# Access Compliance Report

## Public Rights-of-Way

### (Curb Ramps)

Intersection ID: 50607	Main Street: DENBUR_DR	Cross Street: STREAM_ORCHID_LN	Location: NW
ADA ID: 46378844A964	Ramp Type: Perp	Initial Pass/Fail: Fail	Overall Compliance: No
Severity Score: 22.5			
Codes/Mitigation Info/Possible Solution		Field Measurements/Component Compliance

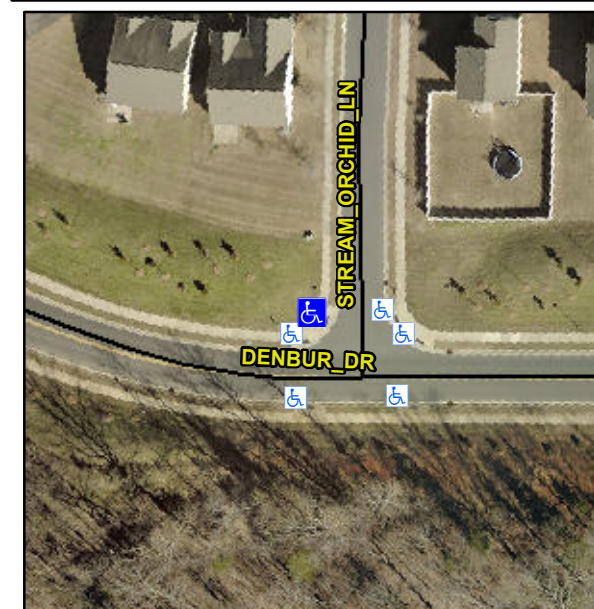
**Not Found, R304.5.1, R304.2.2, R304.5.3**

Compliance	Description	Data	Compliance	Description	Data
N/A	Ramp Length (in)	47.5	No	Ramp Slope (%)	8.4
No	Ramp Width (in)	47.5	No	Ramp XSlope (%)	2.7
N/A	Flare Type LT	N/A	N/A	Flare Type RT	N/A
N/A	Flare Slope LT (%)	N/A	N/A	Flare Slope RT (%)	N/A
N/A	Flare Traversable LT?	N/A	N/A	Flare Traversable RT?	N/A
N/A	Landing Length (in)	N/A	N/A	DWS Provided?	N/A
N/A	Landing Width (in)	N/A	N/A	DWS Contrast?	N/A
N/A	Landing Slope (%)	N/A	N/A	DWS Length (in)	N/A
N/A	Landing X Slope (%)	N/A	N/A	DWS Full Width?	N/A
N/A	Landing Curb? (Y/N)	N/A	N/A	DWS Offset (in)	N/A
N/A	Shared Landing?	N/A			
N/A	Gutter Ponding?	N/A	N/A	Gutter Slope (%)	N/A
N/A	Gutter Lip Ht (in)	N/A	N/A	Gutter X Slope (%)	N/A
N/A	Painted X Walk1?	No	N/A	Painted X Walk2?	N/A
	X Walk 1 Direction	To E		X Walk 2 Direction	N/A
N/A	X Walk 1 Width (in)	N/A	N/A	X Walk 2 Width (in)	N/A
	X Walk 1 Slope (%)	4.5		X Walk 2 Slope (%)	N/A
	X Walk 1 X Slope (%)	2.2		X Walk 2 X Slope (%)	N/A

**Remove & Replace Entire Ramp.**
